The Tauranga Airport understands the Port is seeking resource consent for its proposed Stella Passage development through the Fast-Track consenting process. Associated with the Stella Passage Development is the inclusion of additional ship to shore container handling cranes as shown on drawing 270-118 Rev A and 324-239 Rev 0.

**CRANE HEIGHT RESTRICTIONS
SULPHUR POINT**

CRANE ELEVATION
PROPOSED SOUTHERN WHARF EXTENSION
SULPHUR POINT

DETERMINATION OF HAZARD IN NAVIGABLE AIRSPACE

Figure 05-3 VSS Restriction on Proposed Wharf Expansion

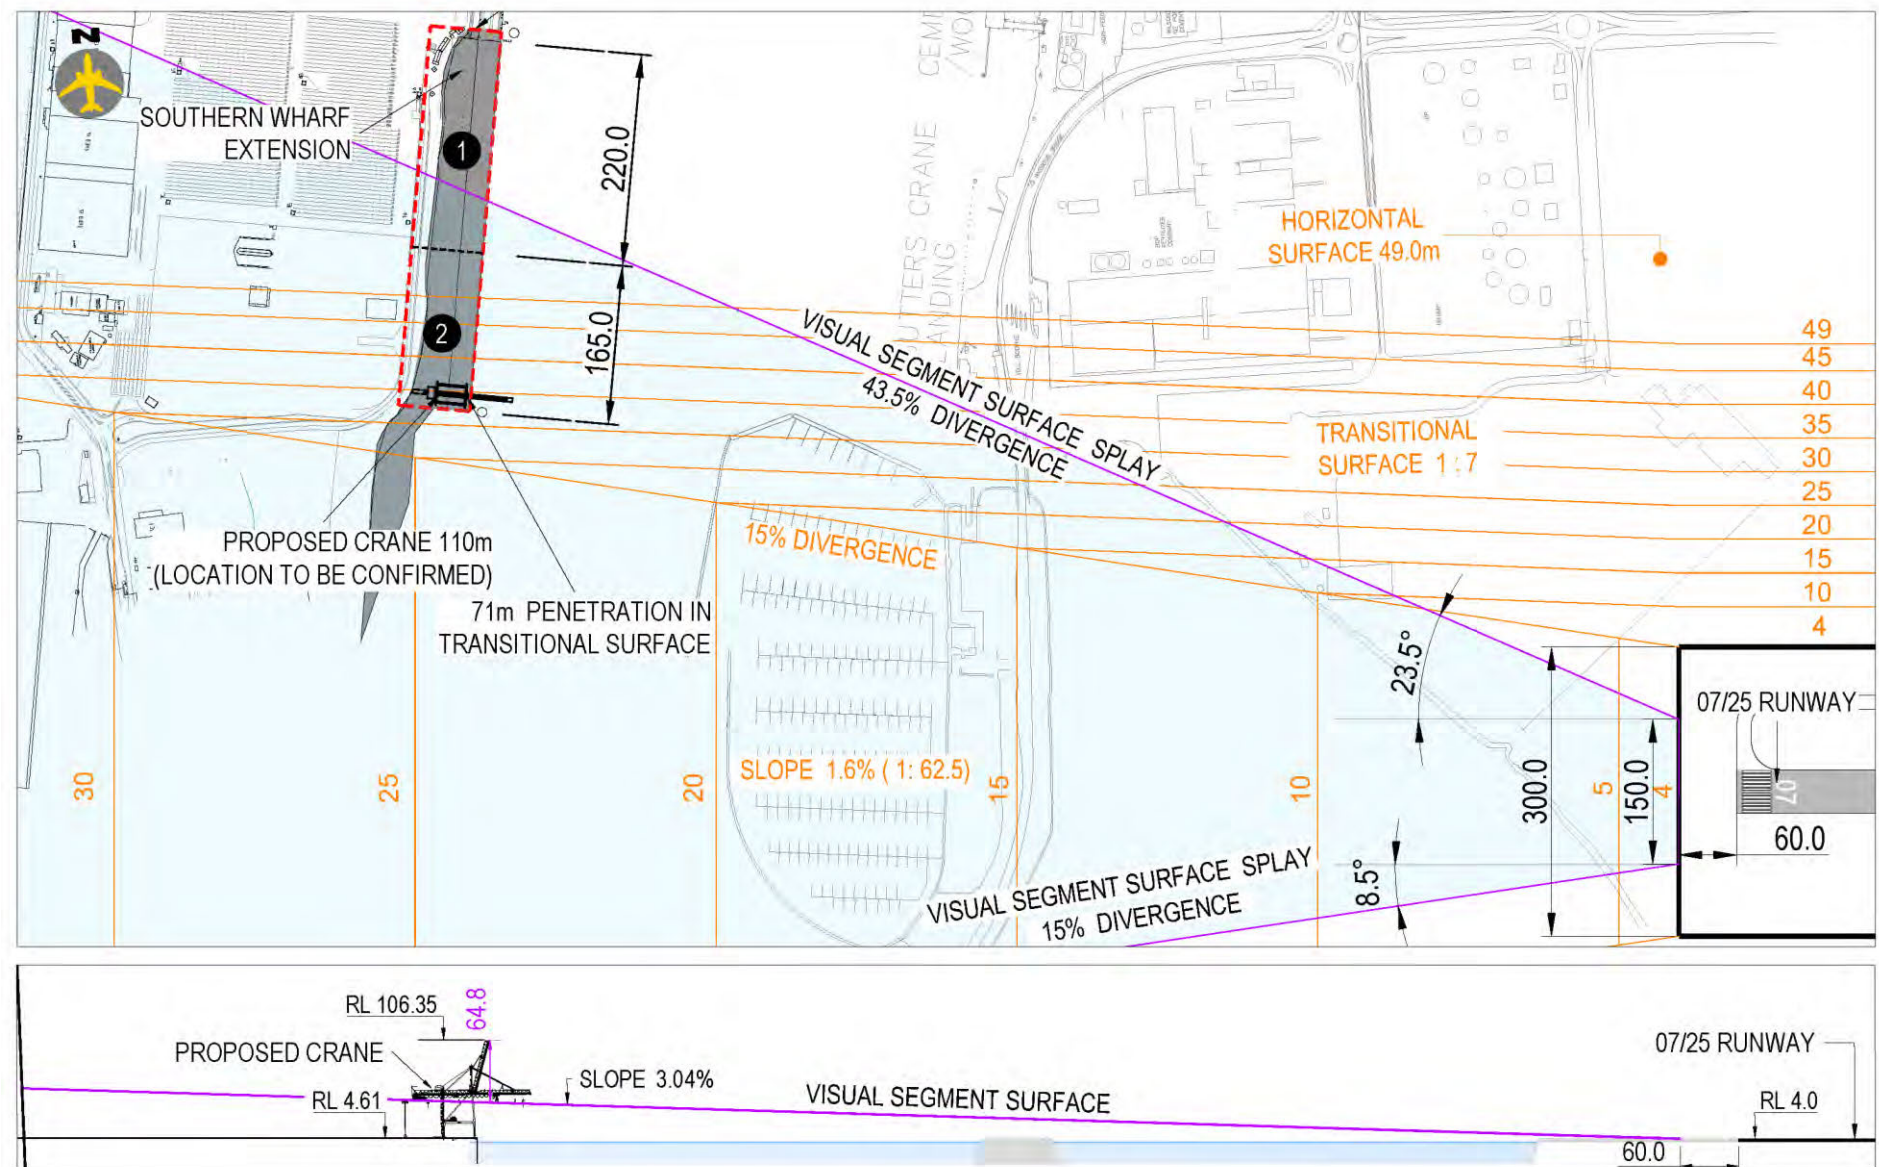
The critical aspect is the requirement that any obstacle must not infringe the VSS, potentially restricting installations in the southern-most third of the initial 220m wharf extension (Area 1) and all of the longer term additional extension to the full 385m extent, denoted as Area 2 in Figure 05-3.

The VSS imposes significant height restriction on more than half of the proposed Port expansion. The VSS is asymmetric to the runway centreline, due to the established flight path having a bias to the north to avoid terrain to the south. The lower profile cranes described in Section 02 above would not be able to fit underneath the current VSS as the available height for a crane would be only approximately 41m. This is illustrated in Figure 05-3.

If the VSS constraint is unable to be resolved by the process of DVOR installation, the only mitigation available would be that TAA could, and have advised that they would revoke the existing NDB/DME RWY 07 approach procedure or the new DVOR/DME RWY 07 approach procedure to remove the VSS constraint.

Figure 05-4 Expected Shape of VSS for a Straight Approach

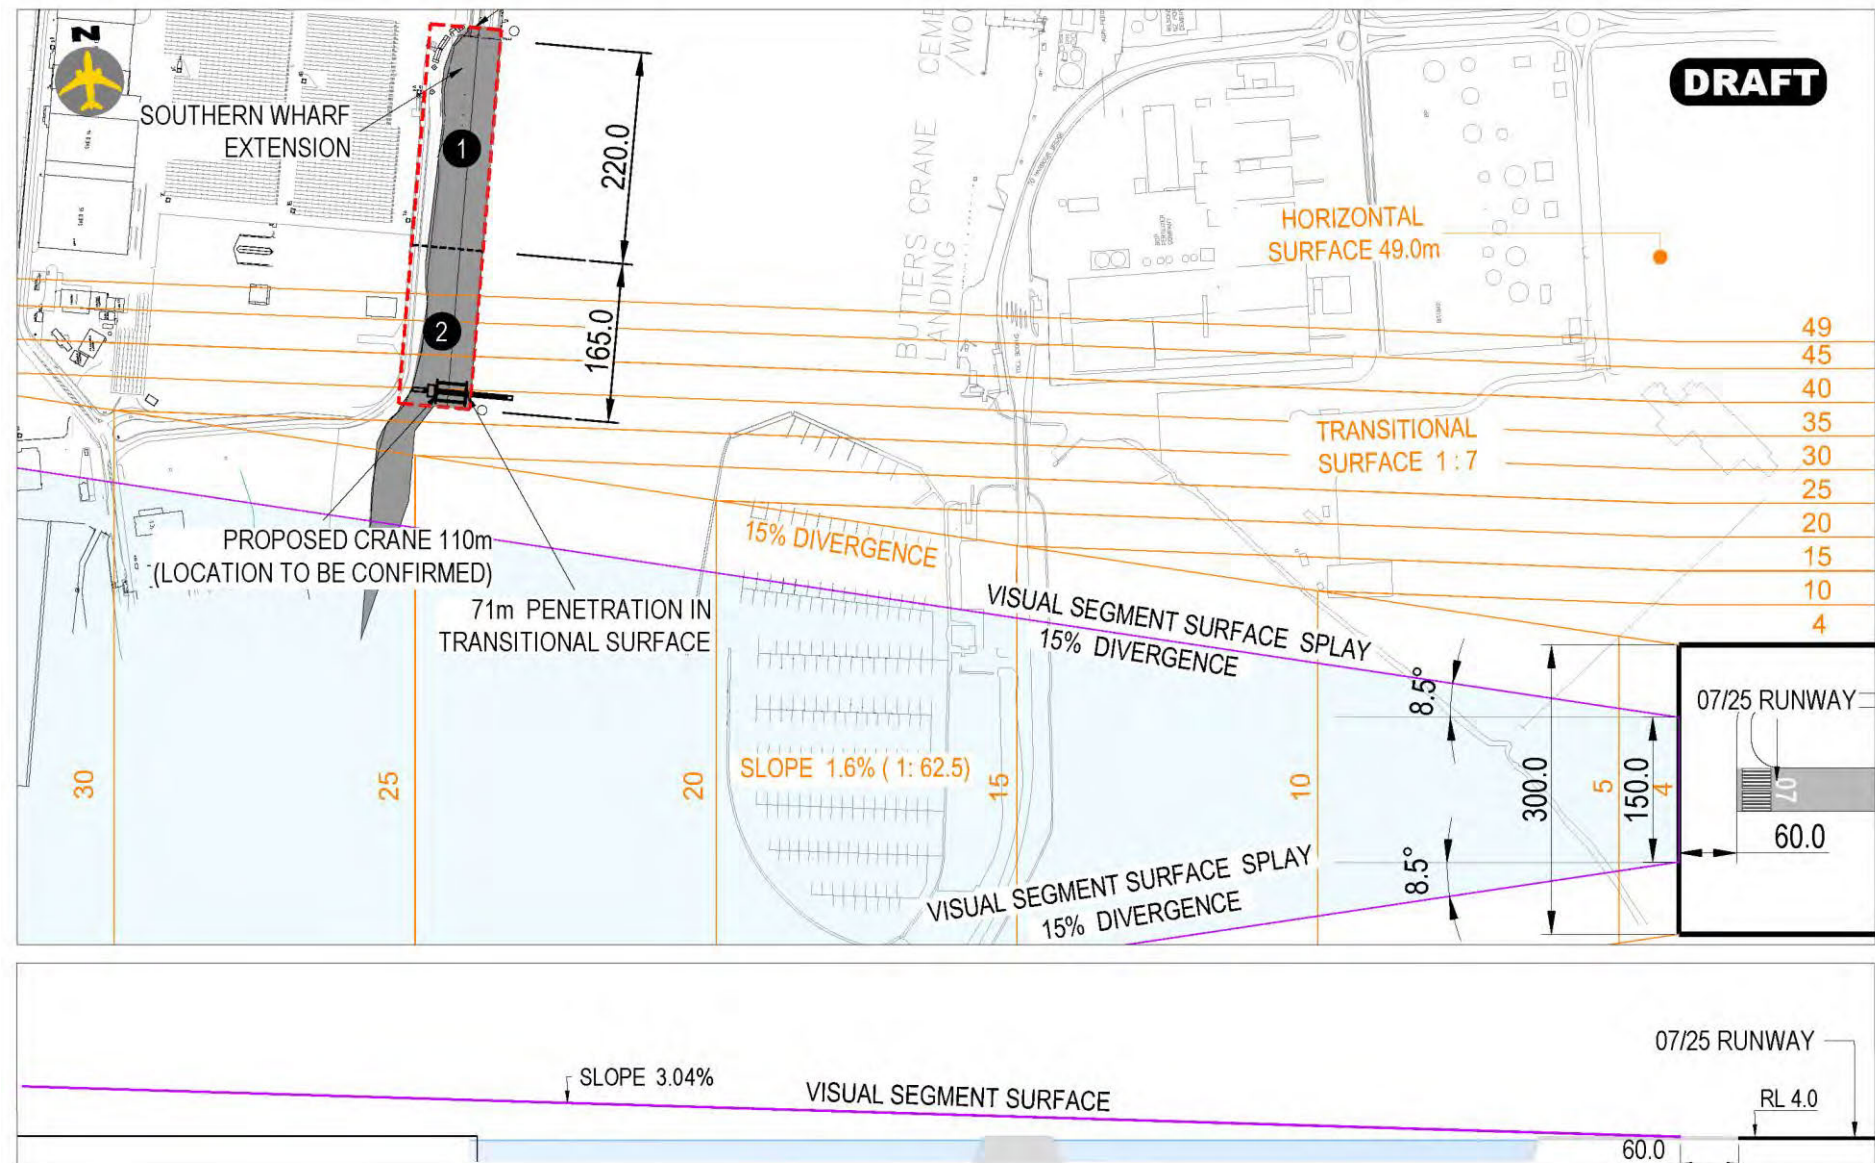
Initial discussions between Airways and the TAA have focused on a site to the south of the sealed Runway 07/25 in close proximity to that runway. It is expected that such a site would enable a straight approach to RWY 07 which would result in a VSS that is “shifted” southwards to achieve a straight-in approach to the runway, which would not overlap the proposed Wharf extension. This is illustrated in Figure 05-4.

Figure 07-2 Proposed changes to AIP NZTG AD 51.1

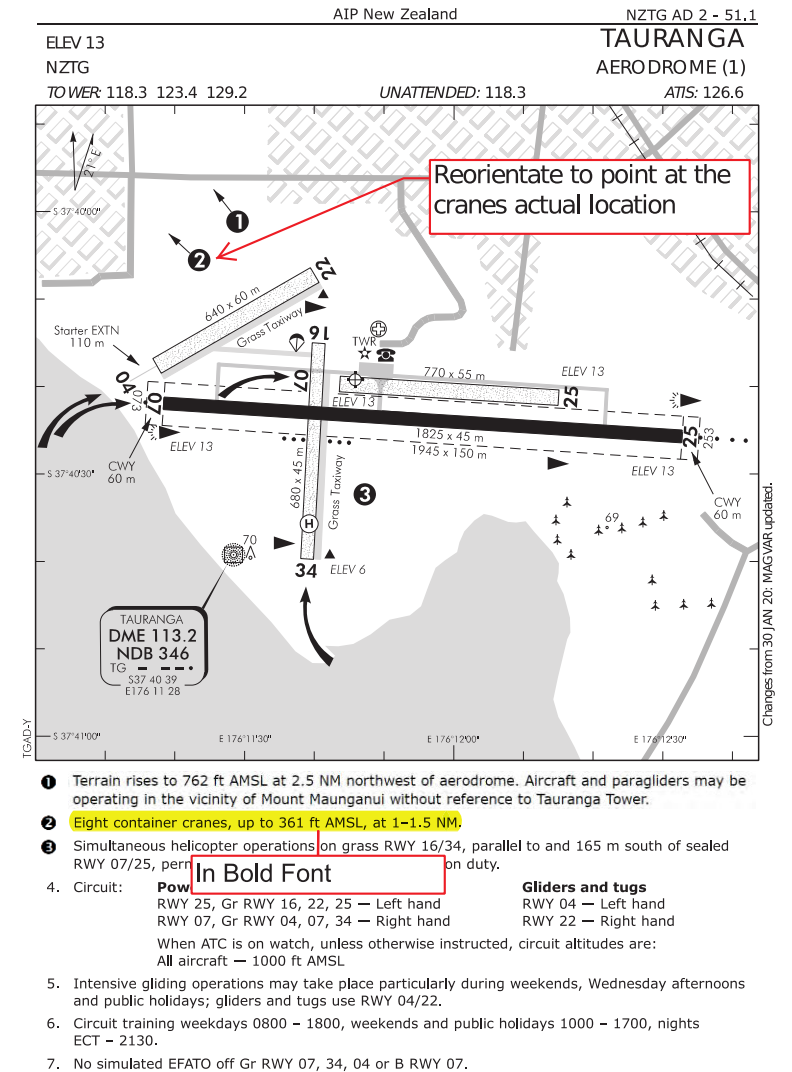
Figure 07-2 shows proposed changes to NZTG AD 51.1. The arrow for Note number 2 is proposed to be changed to point at the Wharf and that the words for Note number 2 should be made **bold**. These words would be updated with the addition of cranes.

Figure 07-3 Proposed changes to AIP NZTG AD 2 64.1 and 64.2

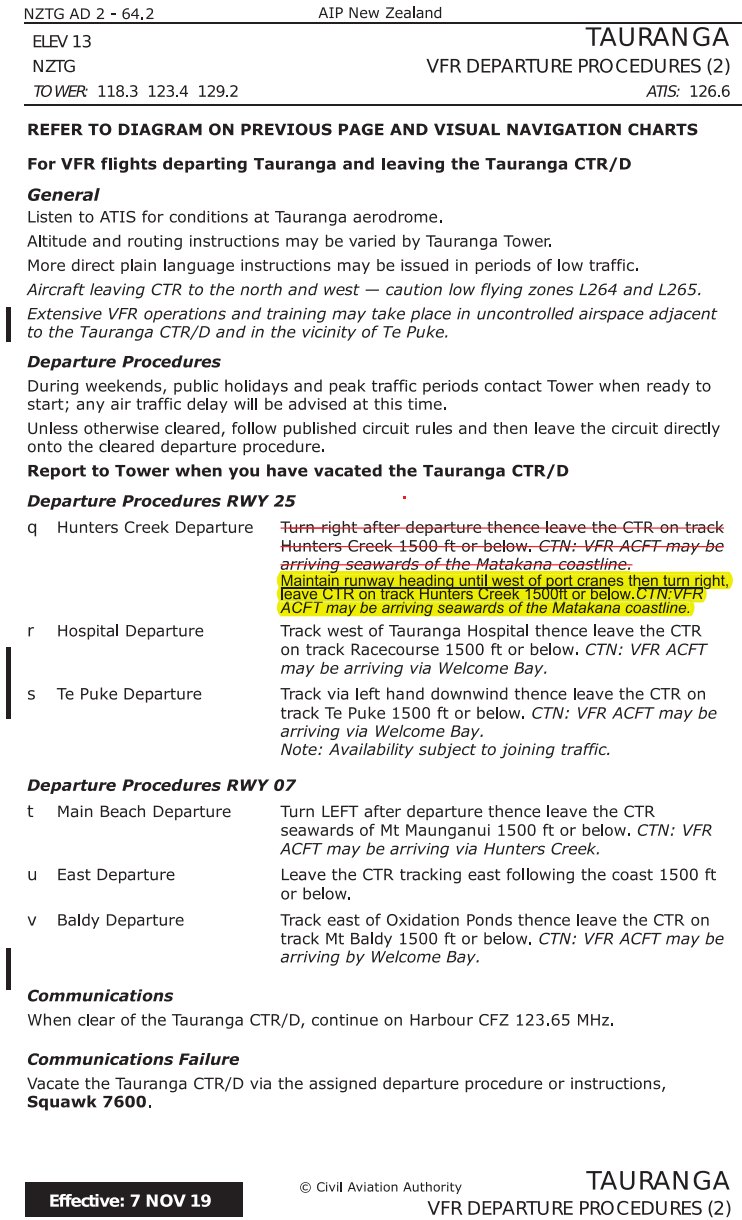
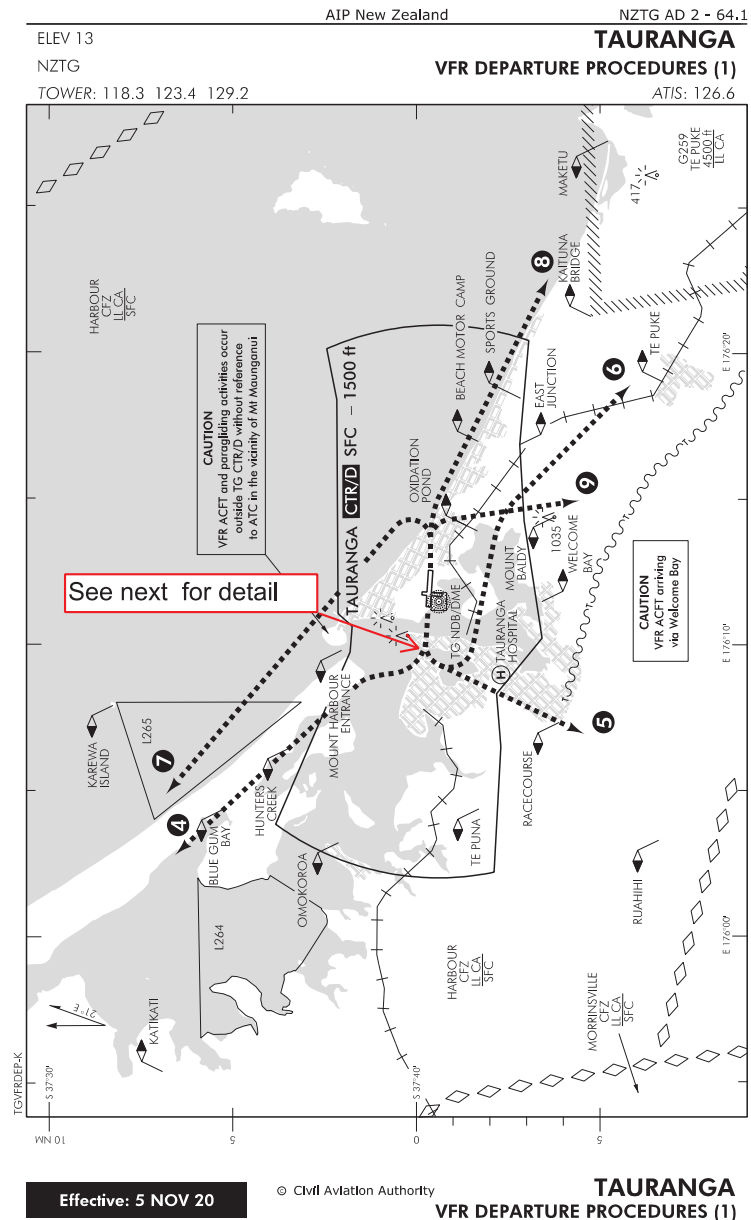
Figure 07-3 below shows proposed changes to NZTG AD 2 64.1 and 64.2. On 64.1 a note is proposed to be added highlighting the guidance on the Departure Procedures RWY 25 given on 64.2. The proposal is to change the wording on 64.2 of the Departure Procedures RWY 25 for the Hunters Creek Departures:
